FLYERS CREEK WIND FARM

REVIEW OF REPORT No 41.4963.R1A:ZSC – 15th December 2011

Review of The Acoustic Group Pty Ltd "Peer Review of Acoustic Assessment Report for Flyers Creek Wind Farm" No 41.4963.R1A:ZSC report dated 15th December 2011.

Attention:	Jonathan Upson	Date:	25 Jan 2012
Company:	Infigen Energy	Pages:	1 of 11
Email:	Jonathan.upson@infigenenergy.com	Document No:	50B-08-0089-GCO-777609-2
From:	Andrew Leonard	Reviewed By:	Dr Peter Teague
Subject:	Peer Review Report Response

Figure 2 – Comparison of NSW baseline A-weighted noise criteria with other jurisdictions

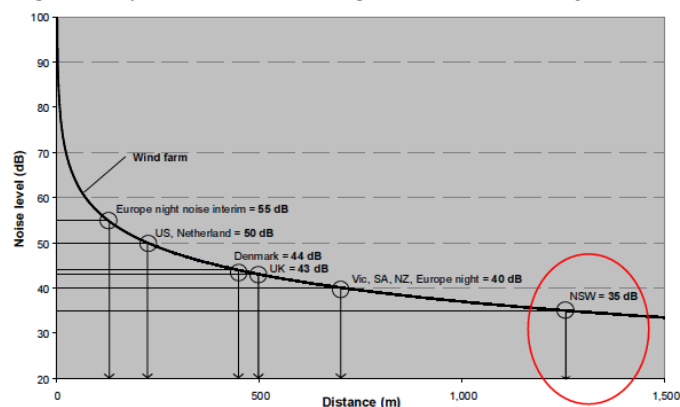
The Acoustic Group report contends that there is a discrepancy between the indicative noise levels for a rural area under the *Environment Protection (Noise) Policy 2007* (the Policy) and the objective criteria of the SA Guidelines. On this basis, it is contended the Policy provides a more stringent approach than the SA Guidelines and therefore wind farms “contravene the obligations created under the legislative framework”.

Notwithstanding the above, the 2003 SA Guidelines are considered to represent one of the most onerous wind farm assessment procedures of any jurisdiction in the world. The Draft for Consultation NSW Planning Guidelines for Wind Farms (December 2011) provides the following figure which indicates the 35 dB(A) baseline criterion relative to other approaches:

Recommendation: No further action
